This Service Information bulletin supersedes SI 52 09 15 dated October 2015.

Delivery Stop - F10 ISOFIX Bracket

F10 (5 Series Sedan)

Produced from July 20, 2015 to September 14, 2015

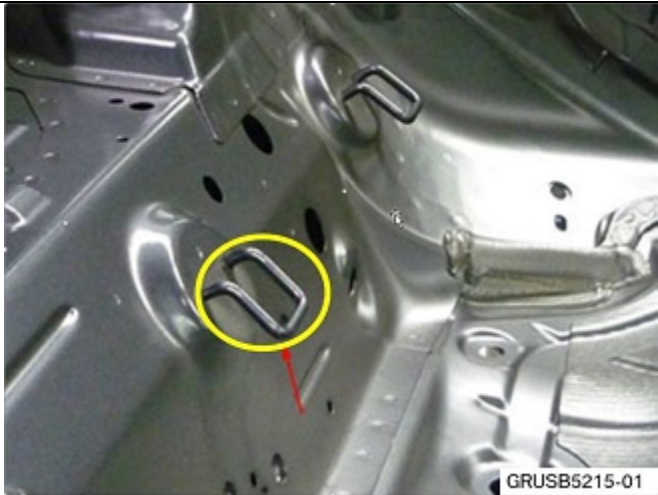
1. Check the gap on the right side bracket of the left side rear seat.

The bracket to be checked is shown.

2. Check the gap between the seat bottom and ISO bracket using an appropriate measuring tool.

Note: The seat bottom to bracket gap must be 4 mm to 6 mm.

3. If the gap is not correct, adjust the bracket by bending the uprights.
4. After the rework, recheck the gap measurement.

Right bracket (anchor) for left rear seating position must be bent into correct position.
